Cross River Rail Environmental Impact Statement

Request for Project Change 14 – Herschel
Street Pocket Park

Changes to the Project and changes to the
Imposed Conditions

Volume 1 Application

Figure 1 RfPC-1 Proposed Herschel Street Closure and Roma Street Intersection Layout

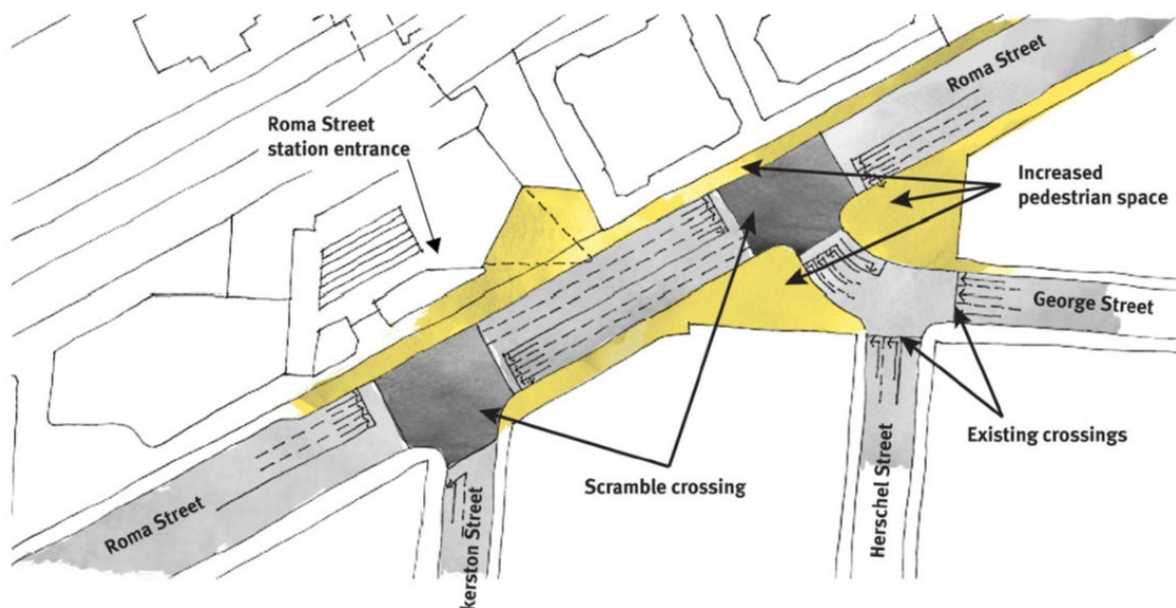
RfPC-1 (Whole of Project, 2017) proposed a change to the Herschel Street interchange between George and Roma Streets that is generally consistent with what is being proposed in RfPC-14. This similar change was described as:

The change application also includes variations to the pedestrian access arrangements along Roma Street. The proposed conceptual layout (see Figure 1) includes the creation of a signalised T intersection of George Street and Roma Street that will include a scramble pedestrian crossing. The T intersection would be created through the realignment of George Street and the removal of the short section of Herschel Street between George Street and Roma Street (Cross River Rail Request for Project Change 1, 2017).

Figure 2 RfPC-4 General Arrangements showing Inner Northern Busway Underground Solution

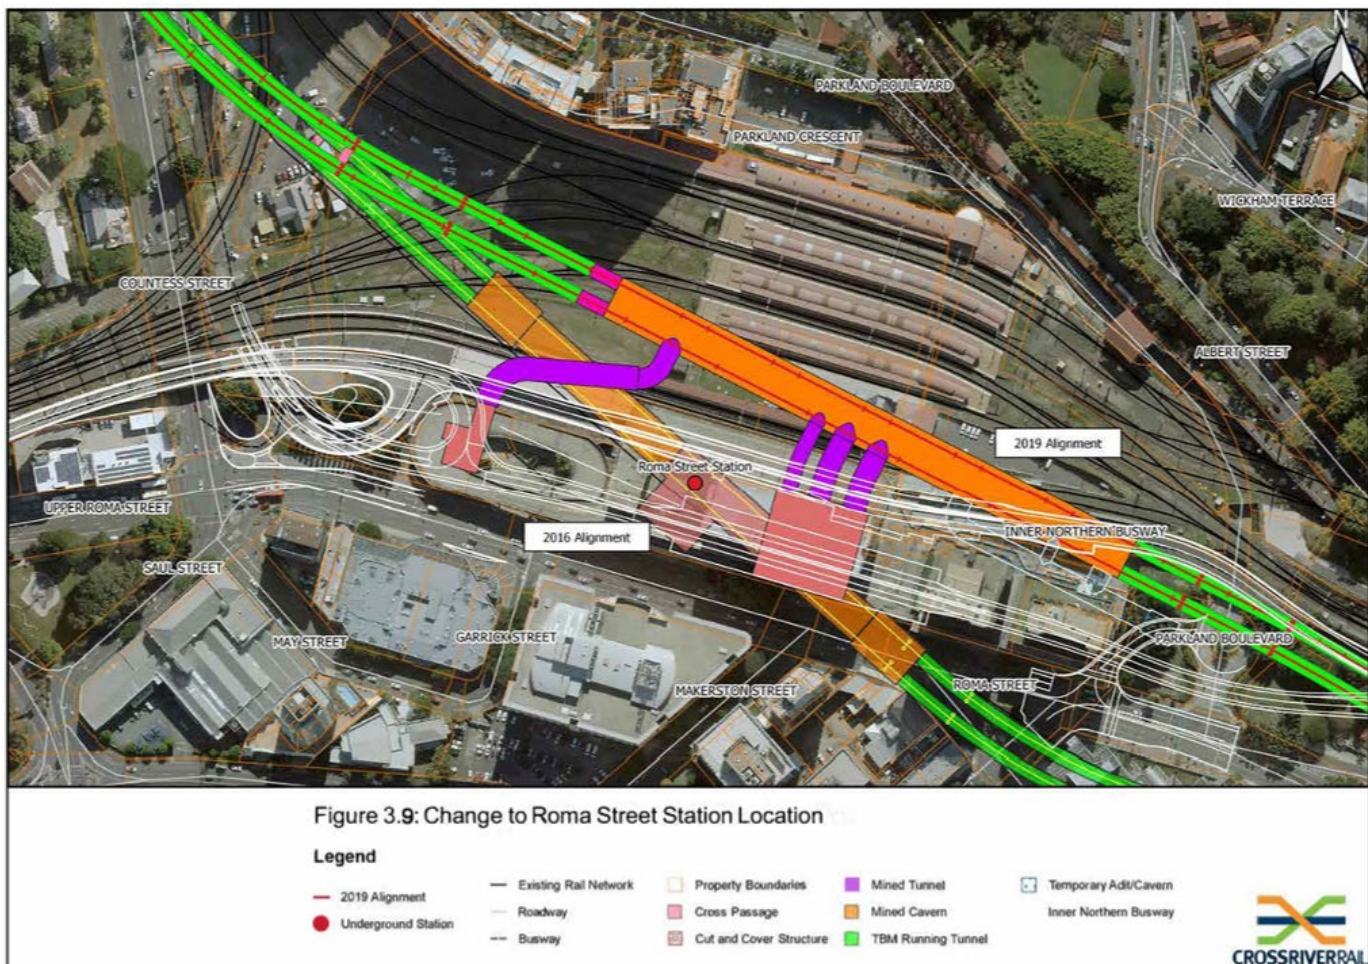
RfPC-4 (Whole of Project Refinements, 2019) proposed a change to the Herschel Street interchange that differs to what is being proposed in RfPC-14. This change was described as:

The proposed changed project also includes works to extend Herschel Street across Lot 60 at Roma Street to connect with Parkland Boulevard. The proposal includes converting the Hotel Jen carpark access from Roma Street into an access which ties into the existing roundabout on Parkland Boulevard. This will allow a connection from Herschel Street via the Hotel Jen carpark access to Parkland Boulevard at the existing roundabout. The Parkland Boulevard roundabout will remain a three-legged roundabout with the existing signalised access to Roma Street removed (see Figure 2) (Cross River Rail Request for Project Change 4, 2019).

Figure 3 Roma Street Station Herschel Street Traffic Change RfPC

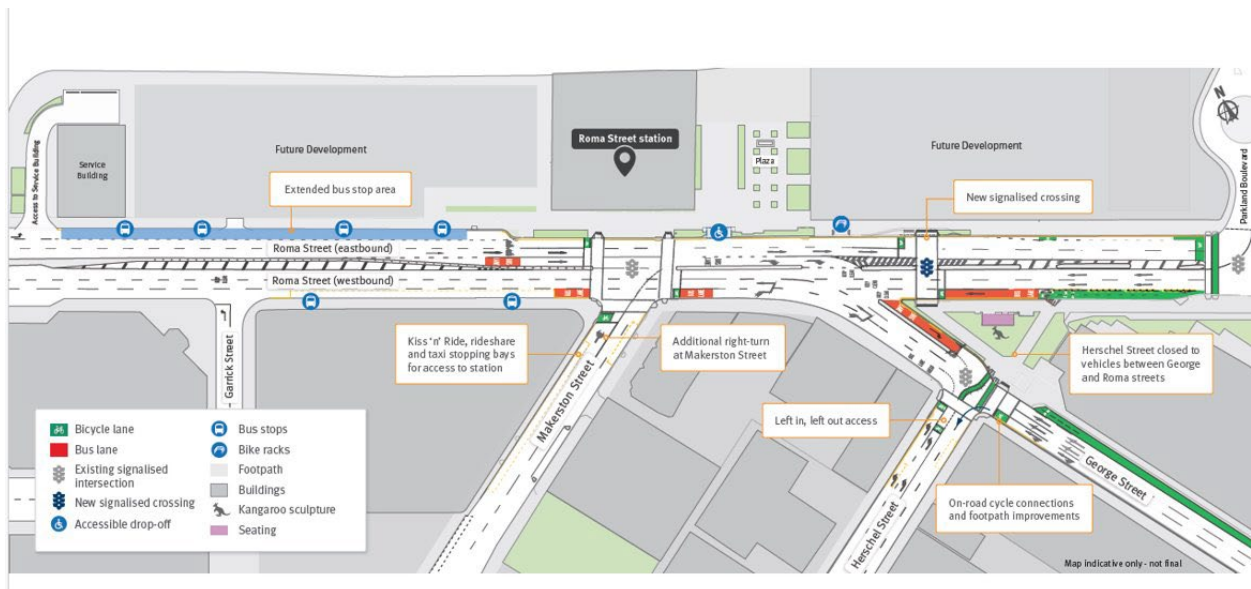
The closure of Herschel Street (Roma to George Street), changes to traffic intersections including modifications to the Makerston Street/Roma Street intersection, new urban design, landscaping and street furniture be returned works to Brisbane City Council (BCC).

The portion of Herschel Street between George Street and Roam Street will be subject to closure to vehicle traffic only, with the road remaining open to pedestrian and active transport users. The underlying land tenure, currently designated as 'road', is not proposed to change. Maintaining the underlying tenure as 'road' preserves the Queensland Government and Brisbane City Council's ability to amend vehicle and pedestrian movement arrangements within the Roma Street precinct over time as development within the Roma Street Priority Development Area and planning for the proposed Brisbane Arena progresses.

The physical extent of the traffic arrangements proposed as part of RfPC-14 and to be included in the Evaluated Project is depicted below in Figure 3.
